***Lakeview SS: Isolate the 'B'-winding of the RSS2 Transformer
Notification of Approval of Connection Proposal
CAA ID Number: 2004-EX193***

Thank you for the data provided on the proposed isolation of the 4.16kV connections to the 'B'-winding of the Reserve Station Service Transformer, RSS2, at Lakeview SS. This work is necessary due to the failure of equipment supplied from this winding.

DIAGRAM 1

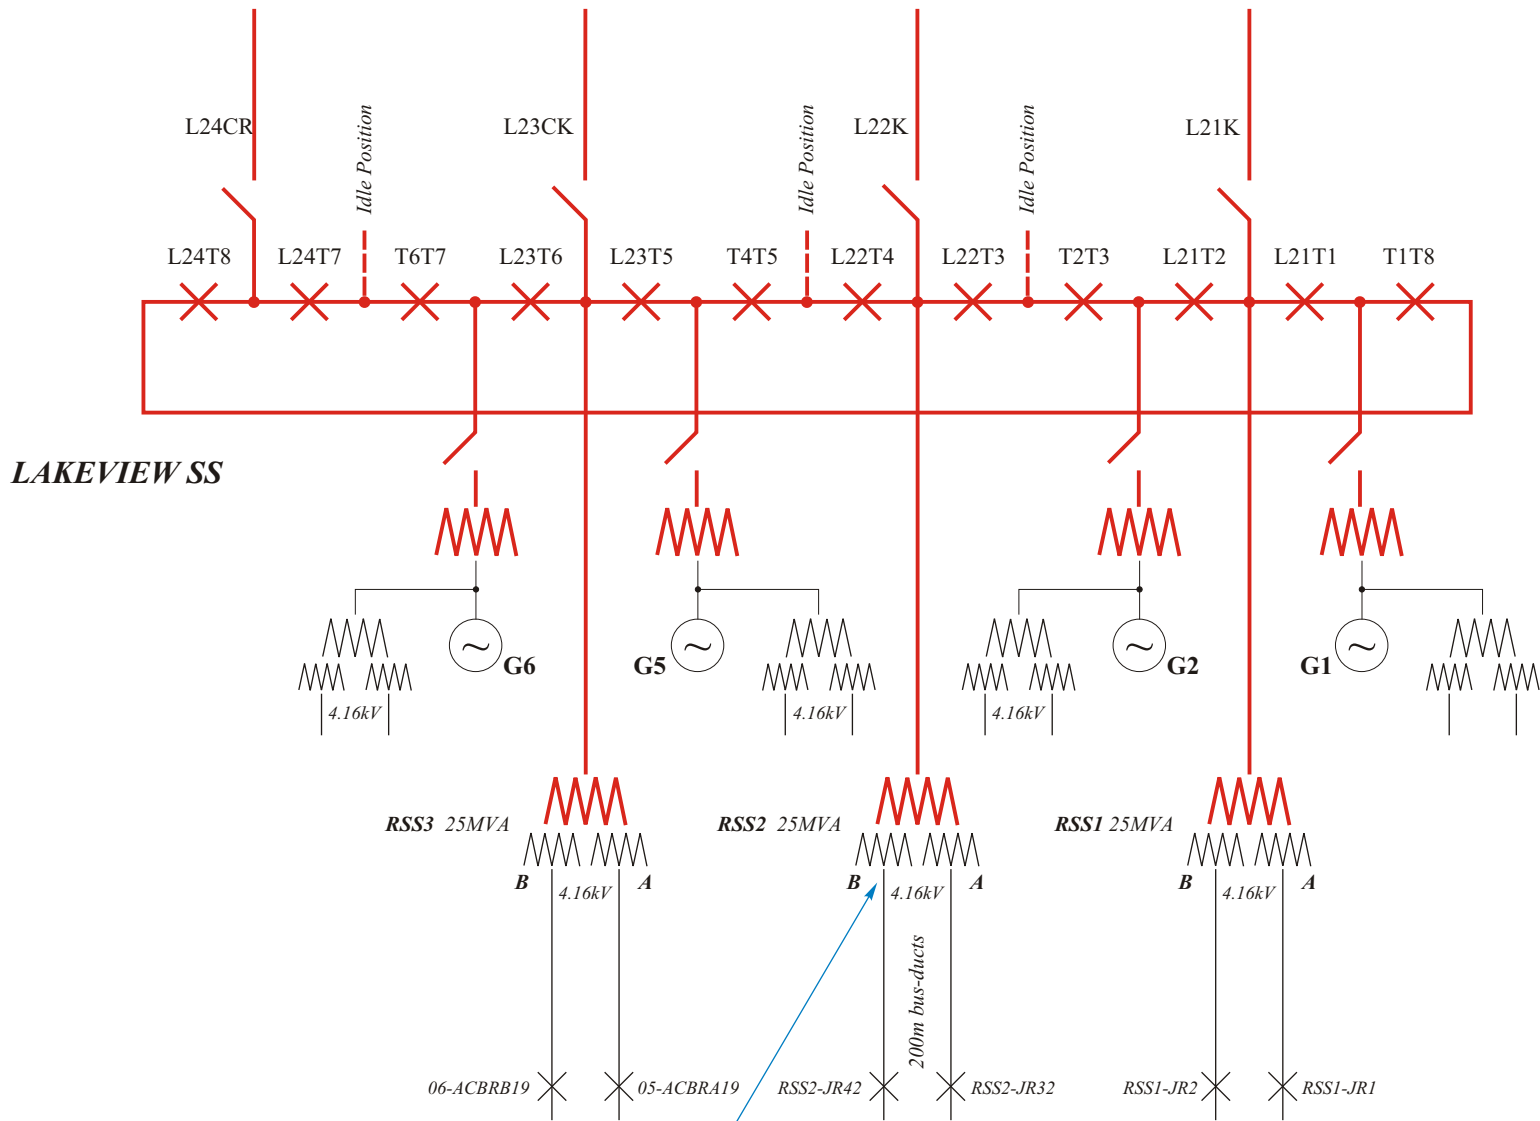
Since the intention of the proposed work is to ensure that the LV connections are permanently isolated, we have concluded that this work will have no adverse impact on the IMO-controlled grid.
[The attached Diagram shows the location of the proposed break.]

Bus-links and a section of the bus-work to be removed to provide a permanent break in the connection to the 'B' winding

Isolation of the bus-work associated with the B- winding of the Reserve Station Service transformer, RSS2, at Lakeview SS

The IMO is therefore pleased to grant **conditional approval** for this work, subject to satisfying any requirements for modifying the existing metering arrangement.
